2019 Annual Inspection Report

Gerald Gentleman Station Ash Disposal Facility

Nebraska Public Power District

Golder Associates Inc.

Notes:

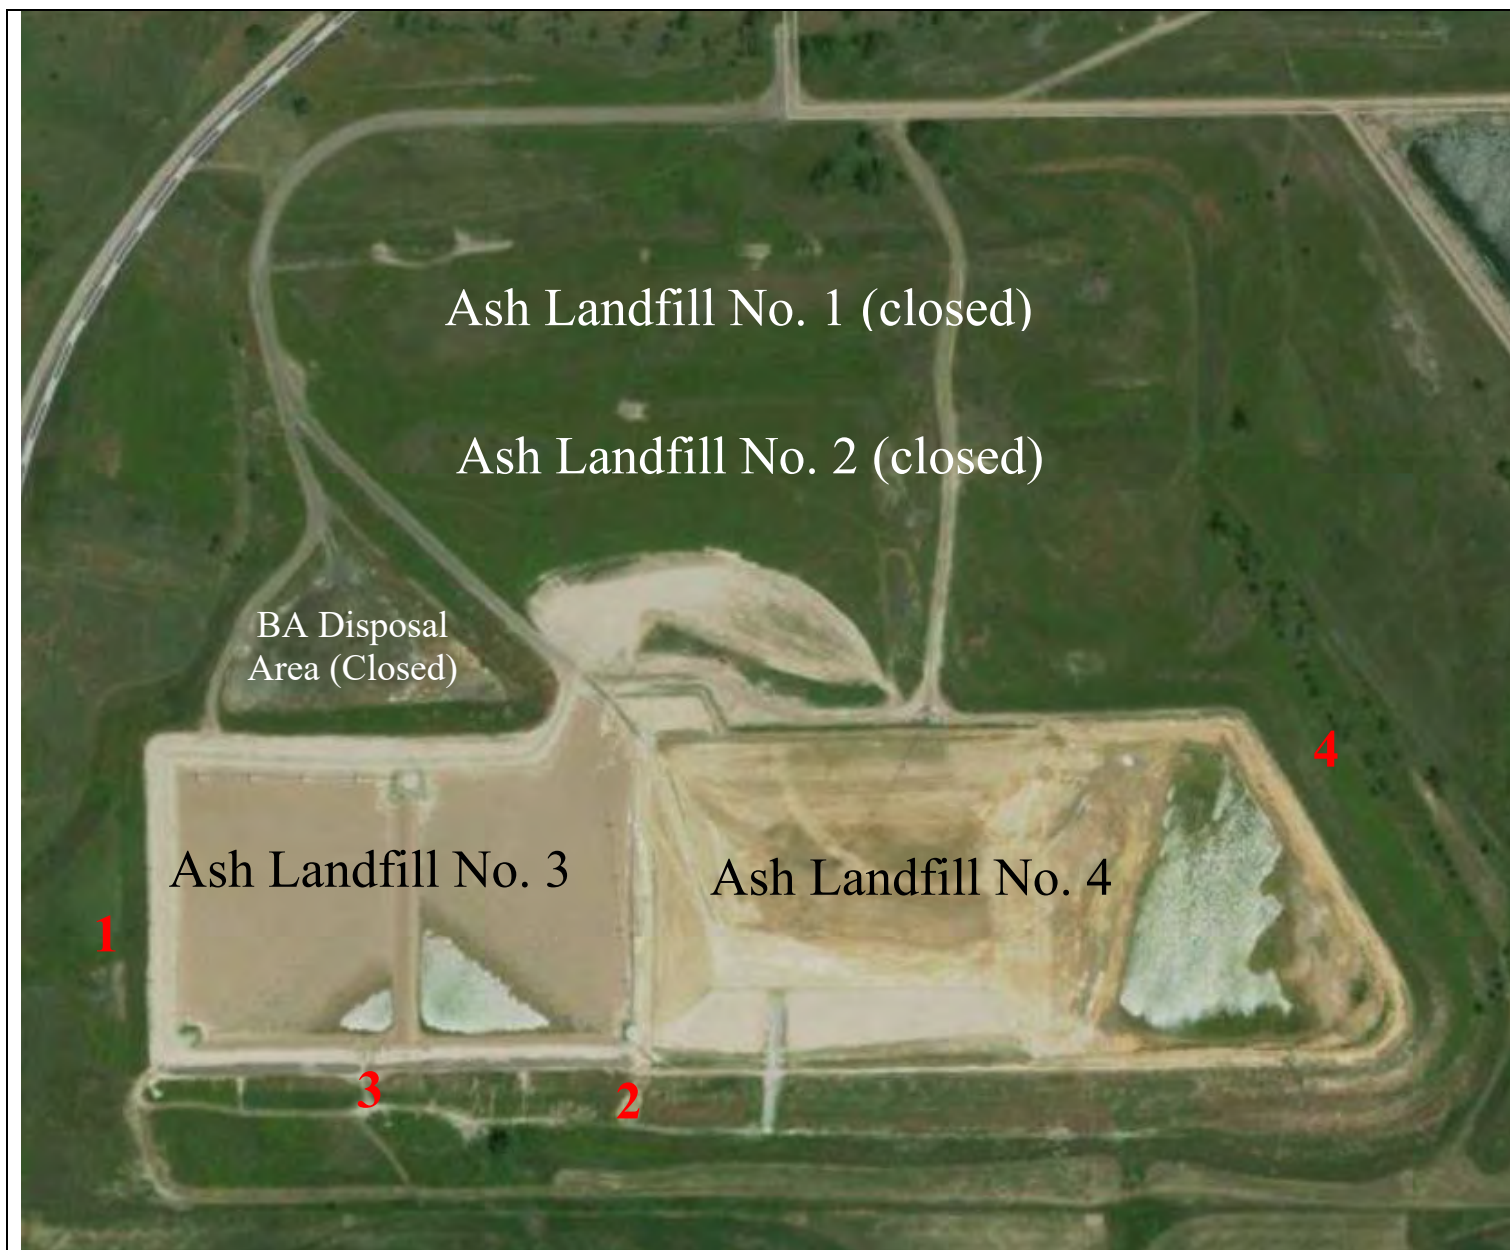
1 – Erosion rills on exterior slope

2 – Erosion west of riprap

3- Area of insufficient vegetation

4 – Small pine tree growing on exterior slope
